# SPILL OF ALGAECIDE OZADO POOL - 8-14-75

We have received the information which you have sent to this office concerning the proposed installation of a tank for storing muriatic acid at the Ozadco Pool Company.

Re: Ozadco Pool

SUGGESTED METHOD FOR VENTING
MURIATIC ACID STORAGE TANKS
NOT REQUIRED IF AIR PADDING IS USED

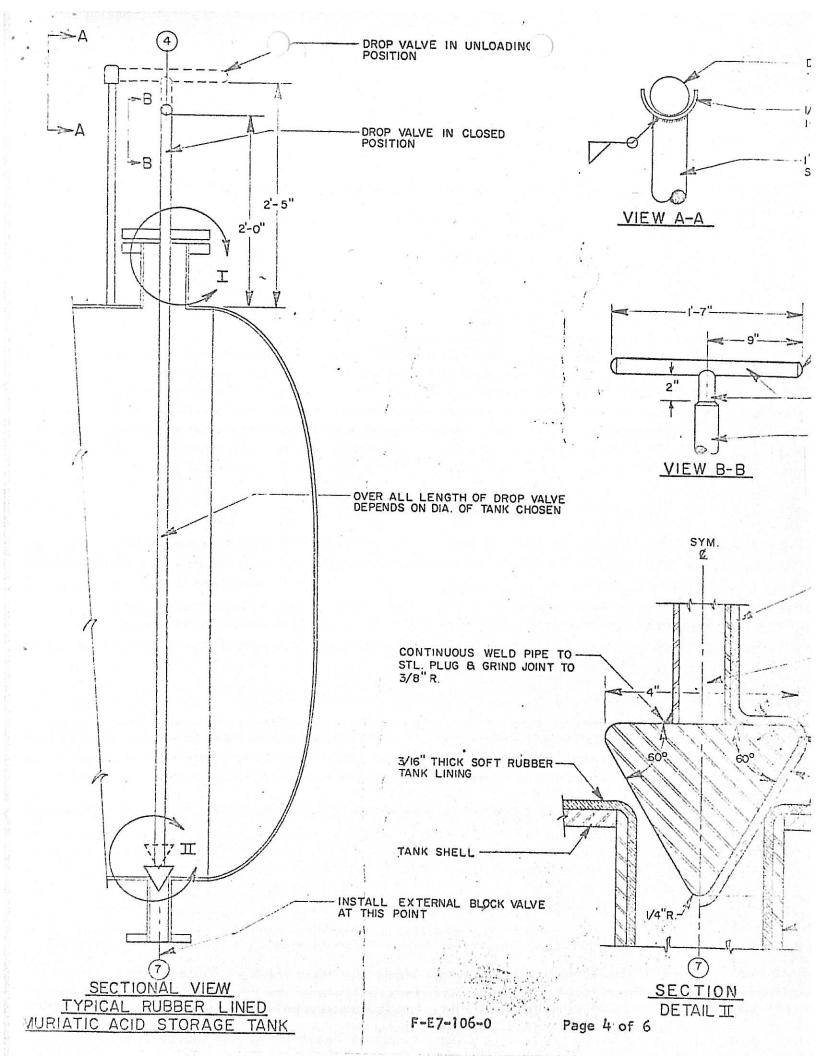
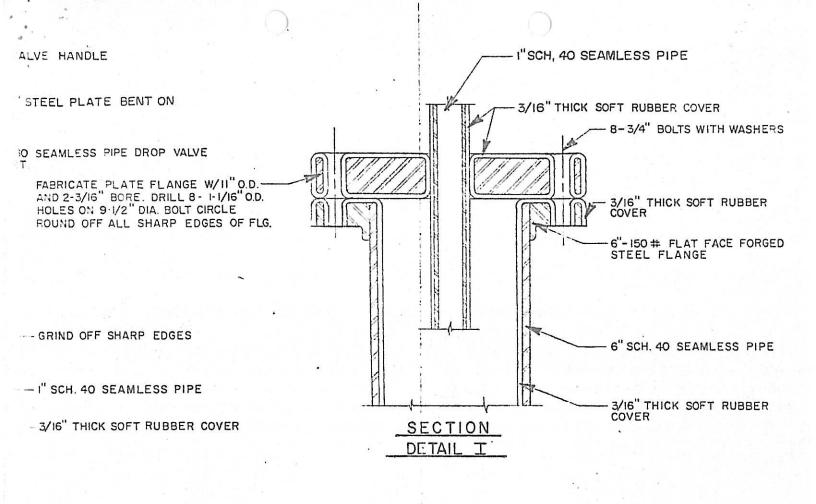
The specifications Ken Beardsley sent mention a vent pipe to be run down into the gravel bed. I would suggest a small separate compartment for this so that periodic replacement of the entire entrapment medium will not be necessary. You could easily replace a separate, small amount fairly often, and still be assured that your main neutralization entrapment dike was not in degraded condition.
